Access Compliance Report

Public Rights-of-Way

Intersection ID: 27493	Main Street: DEERFIELD_CREEK_DR	Cross Street: FAWN_HILL_RD	Location: NW
ADA ID: 26D78F3919C9	Ramp Type: Perp	Initial Pass/Fail: Fail	Overall Compliance: No
Severity Score: 10			
Codes/Mitigation Info/Possible Solution		Field Measurements/Component Compliance

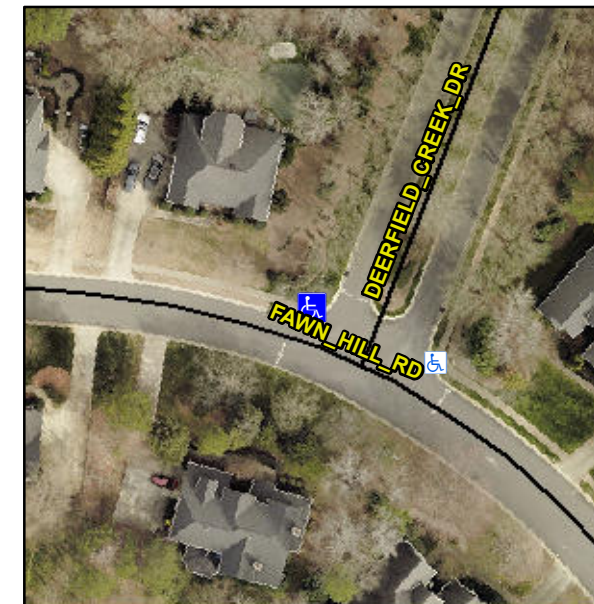
R304.5.1, R304.5.3

Compliance	Description	Data	Compliance	Description	Data
N/A	Ramp Length (in)	48.5	Yes	Ramp Slope (%)	6.5
No	Ramp Width (in)	45.5	No	Ramp XSlope (%)	4.7
N/A	Flare Type LT	N/A	N/A	Flare Type RT	N/A
N/A	Flare Slope LT (%)	N/A	N/A	Flare Slope RT (%)	N/A
N/A	Flare Traversable LT?	N/A	N/A	Flare Traversable RT?	N/A
N/A	Landing Length (in)	N/A	N/A	DWS Provided?	N/A
N/A	Landing Width (in)	N/A	N/A	DWS Contrast?	N/A
N/A	Landing Slope (%)	N/A	N/A	DWS Length (in)	N/A
N/A	Landing X Slope (%)	N/A	N/A	DWS Full Width?	N/A
N/A	Landing Curb? (Y/N)	N/A	N/A	DWS Offset (in)	N/A
N/A	Shared Landing?	N/A			
N/A	Gutter Ponding?	N/A	N/A	Gutter Slope (%)	N/A
N/A	Gutter Lip Ht (in)	N/A	N/A	Gutter X Slope (%)	N/A
N/A	Painted X Walk1?	No	N/A	Painted X Walk2?	N/A
	X Walk 1 Direction	To SE		X Walk 2 Direction	N/A
N/A	X Walk 1 Width (in)	N/A	N/A	X Walk 2 Width (in)	N/A
	X Walk 1 Slope (%)	7.3		X Walk 2 Slope (%)	N/A
	X Walk 1 X Slope (%)	1.1		X Walk 2 X Slope (%)	N/A

Remove & Replace Entire Ramp.
